Access Compliance Report

Public Rights-of-Way

Intersection ID: 23124	Main Street: MOSS_RD	Cross Street: LAUREL_TRACE_DR	Location: SW
ADA ID: DC8B2F00C59F	Ramp Type: Perp	Initial Pass/Fail: Fail	Overall Compliance: No
Severity Score: 21.25			
Codes/Mitigation Info/Possible Solution		Field Measurements/Component Compliance

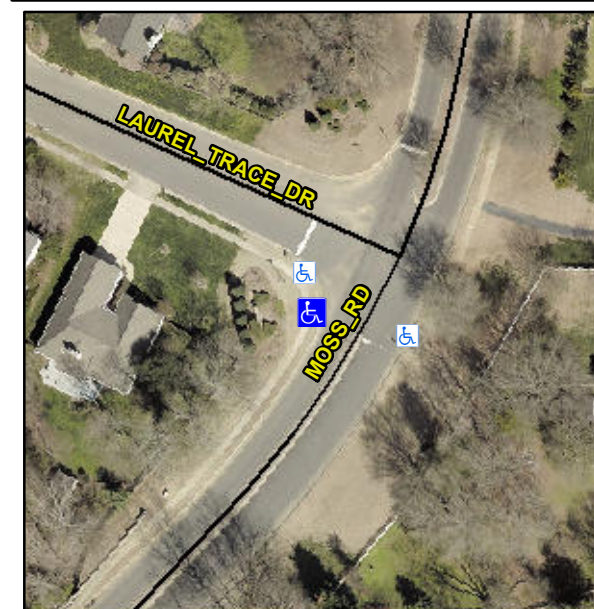
Not Found, R304.5.1, R304.2.2

Compliance	Description	Data	Compliance	Description	Data
N/A	Ramp Length (in)	45.0	No	Ramp Slope (%)	8.5
No	Ramp Width (in)	45.0	Yes	Ramp XSlope (%)	0.9
N/A	Flare Type LT	N/A	N/A	Flare Type RT	N/A
N/A	Flare Slope LT (%)	N/A	N/A	Flare Slope RT (%)	N/A
N/A	Flare Traversable LT?	N/A	N/A	Flare Traversable RT?	N/A
N/A	Landing Length (in)	N/A	N/A	DWS Provided?	N/A
N/A	Landing Width (in)	N/A	N/A	DWS Contrast?	N/A
N/A	Landing Slope (%)	N/A	N/A	DWS Length (in)	N/A
N/A	Landing X Slope (%)	N/A	N/A	DWS Full Width?	N/A
N/A	Landing Curb? (Y/N)	N/A	N/A	DWS Offset (in)	N/A
N/A	Shared Landing?	N/A			
N/A	Gutter Ponding?	N/A	N/A	Gutter Slope (%)	N/A
N/A	Gutter Lip Ht (in)	N/A	N/A	Gutter X Slope (%)	N/A
N/A	Painted X Walk1?	No	N/A	Painted X Walk2?	N/A
	X Walk 1 Direction	To SE		X Walk 2 Direction	N/A
N/A	X Walk 1 Width (in)	N/A	N/A	X Walk 2 Width (in)	N/A
	X Walk 1 Slope (%)	1.5		X Walk 2 Slope (%)	N/A
	X Walk 1 X Slope (%)	1.5		X Walk 2 X Slope (%)	N/A

Remove & Replace Entire Ramp.
